SERVICE TECHNICAL INFORMATION

ONE POINT REPAIR

UTSUNOMIYA, NOVEMBER 15, 1995
 REF. NO. : SI-95-036
 CUSTOMER RELATIONS & SERVICE DIV.

- MODEL : NSX-V30 / V31G / V33 / AP1MK2
 SUBJECT : Changing brightness of FL display
 SYMPTOM : The FL display flickers when T-BASS is ON and the volume is at or beyond the 10 o'clock position. If such a problem is indicated by the customer, perform the remedy described below.
 REMEDY : As shown in the diagram below, add 3 electrolytic condensers and 2 diodes to the MAIN C.B. and remove 1 jumper wire.

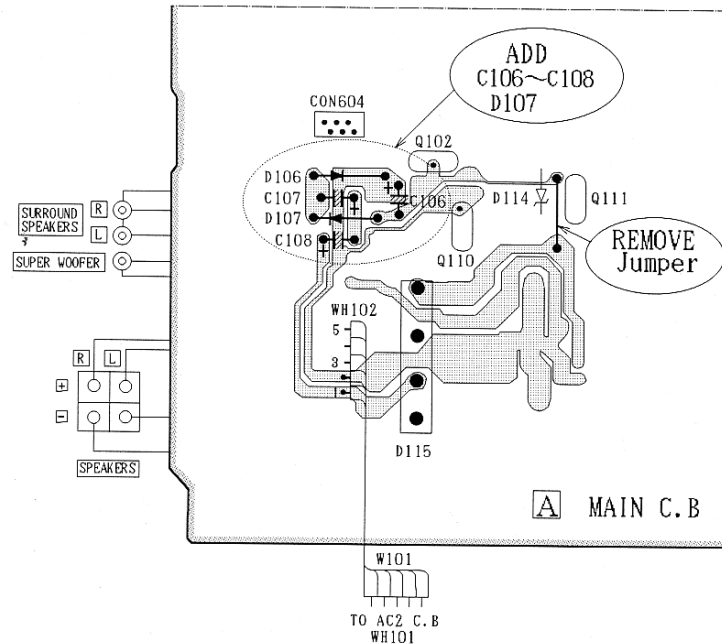
Before modification

After modification

Parts No.	Parts Name	Ref No.
87-010-408-010	Electrolytic condenser 47 μ F•50V	C107 / C108
87-017-978-080	Diode IN4003	D106 / D107
87-010-764-080	Electrolytic condenser 47 μ F•63V	C106
